SUBSURFACE WASTEWATER DISPOSAL SYSTEM APPLICATION

Town Or Plantation	AUGUSTA
Street Subdivision Lot #	8 ROD ROAD

AUGUSTA PERMIT # 903 TOWN COPY

SITE PLAN — Scale 1" = 50' Ft.

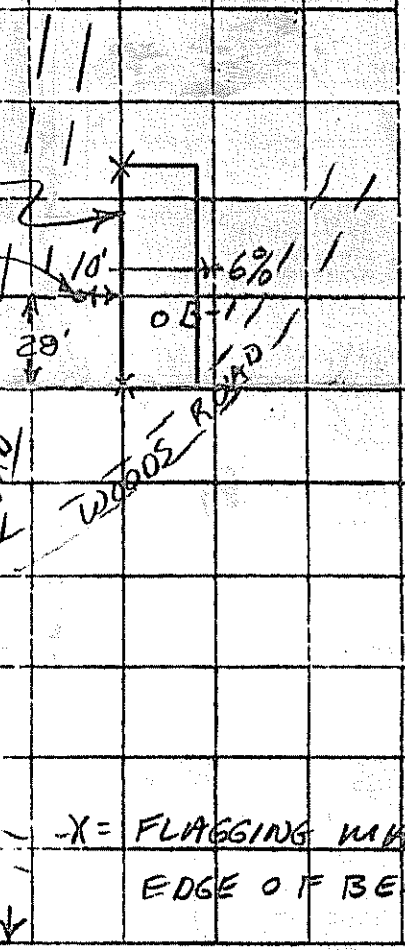
Your top of stone and pipe is 8" to low. You will need to remove the bag and KNOLL pipes and (HOUSE SITE) ADD 8" of new stone
